CAIRNGORMS NATIONAL PARK AUTHORITY

- Title: REPORT ON CALLED-IN PLANNING APPLICATION
- Prepared by: NEIL STEWART, PLANNING OFFICER (DEVELOPMENT MANAGEMENT)

DEVELOPMENT PROPOSED: FULL PLANNING PERMISSION FOR ERECTION OF DWELLINGHOUSE, LAND TO REAR OF HILLCREST, NETHYBRIDGE ROAD, BOAT OF GARTEN

REFERENCE: 06/270/CP

Fig. 5. Location plan, site plan and site section

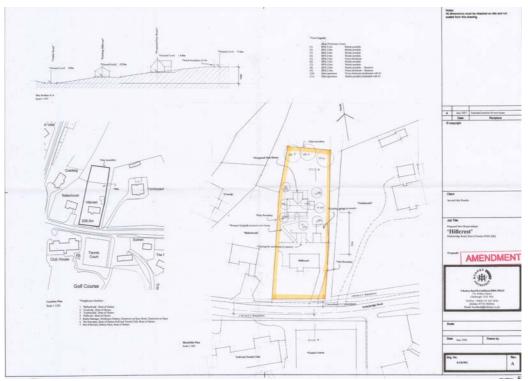
- 16. The original proposal was for a house located on the higher slope of birch woodland, outwith the established domestic curtilage, at a distance of over 35m from the rear of "Hillcrest". Being in this location, the proposed house was sited in an area where Policy 5.10.4. (Amenity) of the Badenoch and Strathspey Local Plan provided a presumption against new development unless it was associated with existing recreational, agricultural or forestry activities. This policy also covers other areas of undeveloped land surrounding Boat of Garten and essentially aims to protect the natural setting of the settlement. This policy presumption against development led to the application being called-in by the CNPA.

- 17. Following discussions with the applicant's agent, a revised proposal was submitted which brings the actual siting of the proposed house further down the slope towards the rear of "Hillcrest" and outwith the restrictive "Amenity" policy designation. Although the site boundaries ie. the proposed domestic garden area for the new house, still extend into the "Amenity" area. I feel that the revised positioning of the house within the site provides two advantages. Firstly it takes it physically out of the restrictive "Amenity" policy area. Secondly, it moves it further down the slope and thus reduces its elevation in the landscape. However, the revised positioning, now puts the house in the "Infill" This policy covers substantial parts of the existing policy area. residential areas in Boat of Garten. Its aim is to protect the character of these areas and as such provides a presumption against infill development unless it can meet certain criteria - please refer to Essentially, the proposal now needs to be paragraph 6 above. assessed in relation to these criteria.

- 20. However there are some areas of concern. These relate to a potential substandard and reduced standard of amenity for "Hillcrest". Although there remains a distance of over 20m between the properties, the proposed house will be higher than "Hillcrest" and overlook, down the slope, across land which would normally be considered to be private amenity ground belonging to "Hillcrest". Indeed, the siting of the new house now removes any significant private rear garden space for "Hillcrest" and no formal sub-division of garden areas is proposed. In addition, the route of the shared access is very close to "Hillcrest" and the parking and manoeuvring space for each property is essentially shared on the land between the two properties and in close proximity to "Hillcrest". It certainly could be argued that these arrangements would be inadequate and unacceptable, if the properties were to be in separate and unrelated ownership.

- 2. That from the date at which this planning permission is granted, no trees on the site, other than those shown on the approved plan for removal, shall be uprooted or damaged. Trees on the site shall only be felled with the prior written approval of the CNPA acting as Planning Authority.

- 3. That no development shall commence on this site until the trees marked for retention on the approved plan, have been protected to the satisfaction of the CNPA acting as Planning Authority, and in accordance with BS5837:2005, Trees in Relation to Construction.

- 4. Replacement tree planting, in accordance with the details shown on the approved plan, shall be carried out to the satisfaction of the CNPA acting as Planning Authority, within the first planting season following completion of the development. Any new trees which in the opinion of the CNPA acting as Planning Authority, are dying, being severely damaged or becoming seriously diseased within five years of planting, shall be replaced by trees of similar size and species to those originally required to be planted.

Fig. 6. Elevations and Floorplans

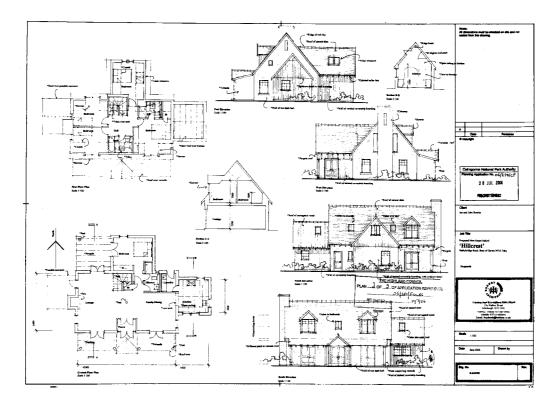
- concern about the use of metal corrugated roof sheeting on part of the house.
 - there is limited space for parking and manoeuvring for both properties on the site this is unsafe to the occupiers.

23. Some concern has been raised about the design of the proposed house and in particular the proposed metal roof sheeting on the single storey wing. I have no such concerns about the design. I find it wholly acceptable for this site in terms of its character, appearance and finishing materials. As a single storey wing accommodating the kitchen, the proposed roof cladding complements the proposed timber cladding on this part of the house. A condition can be imposed requiring exact details prior to construction.

- 5. That prior to the commencement of the following individual works, exact details and specifications (samples may be required) shall be provided for the further written approval of the CNPA acting as Planning Authority;

- i. the corrugated metal roof sheeting;
 - ii. the wet harl wall finish;
 - iii. the windows which shall be timber framed;
 - iv. the type and colour of the timber wall cladding; and
